Service Bulletin

No. 59-41

No. 59-50

RESONANCE
OR
PERIOD

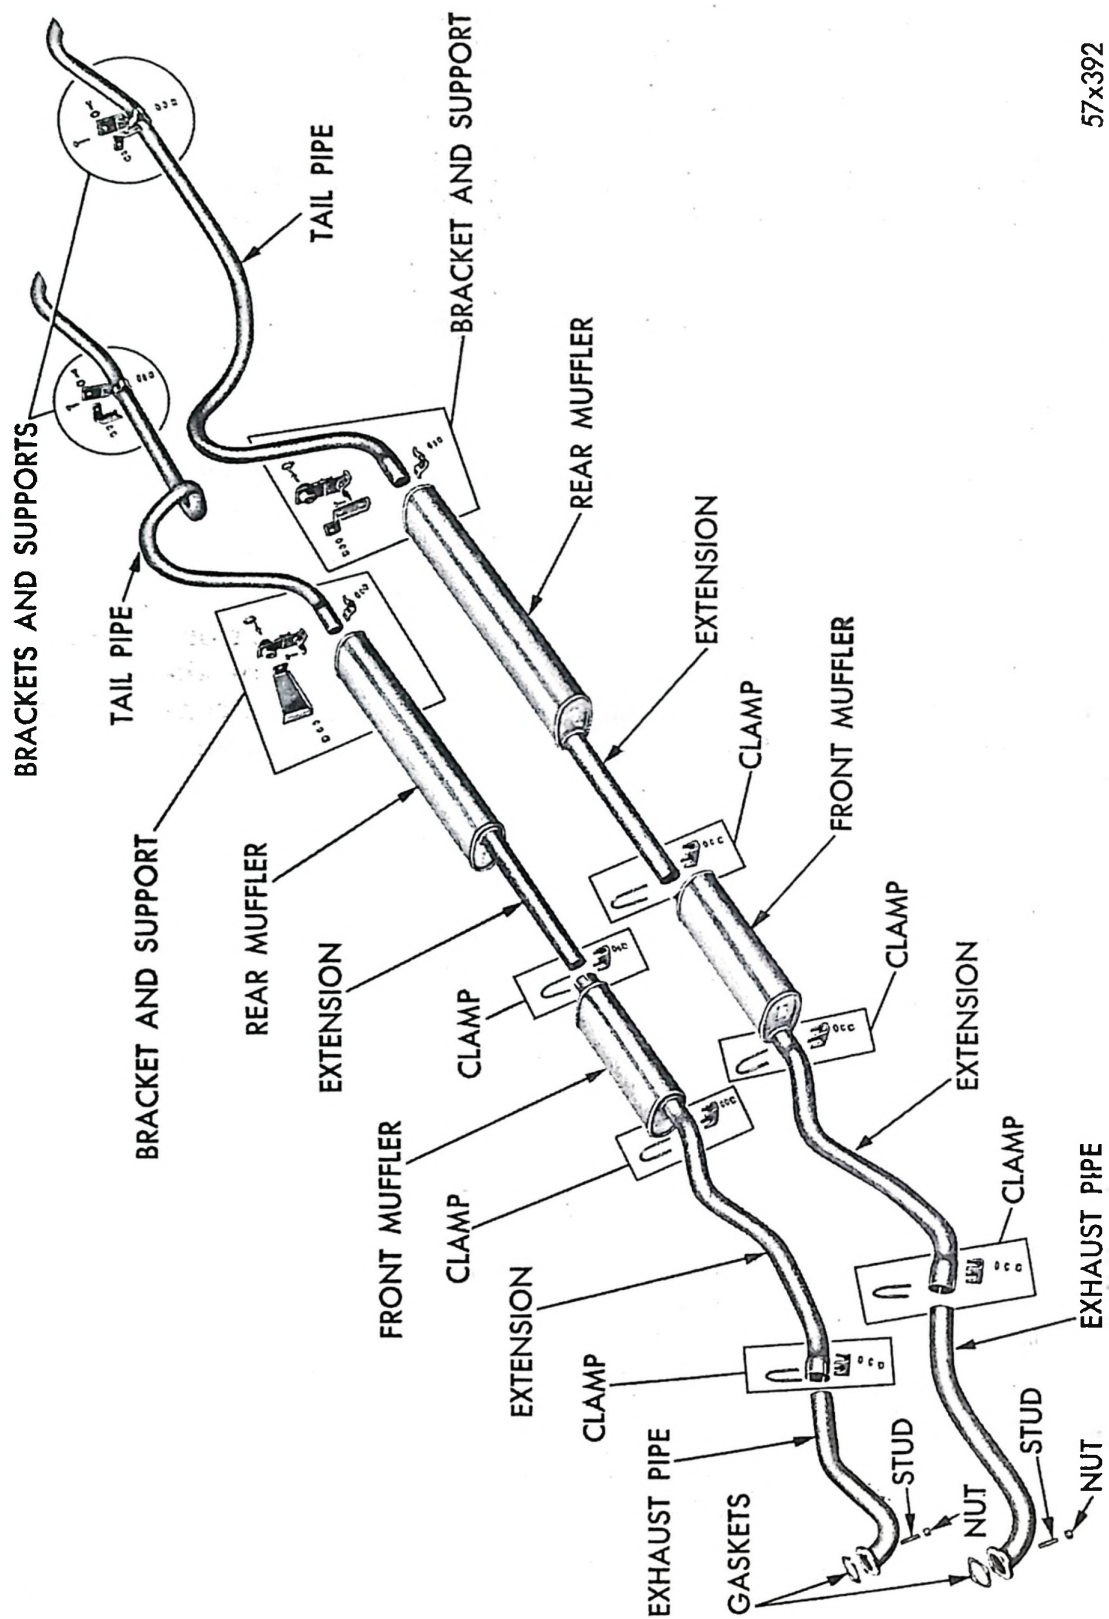
- (3) General tightening of all chassis and body parts that might vibrate. Tighten the exhaust manifolds to the cylinder heads.
- (4) Loosen entire exhaust system (see illustration). Neutralize, align and tighten the entire exhaust system at each point of junction. It is very important that every part of the exhaust system is properly aligned and supported. The supports must carry the load in a truly vertical line, and the large diameter center of the oval muffler ellipse is in a true transverse horizontal plane. In some cases it may be necessary to heat the exhaust pipes and slightly bend them to obtain satisfactory alignment. Be sure the tail pipes are accurately located between the fuel tank and frame side member. Be sure that the support metal members are satisfactorily insulated and do not contact each other.
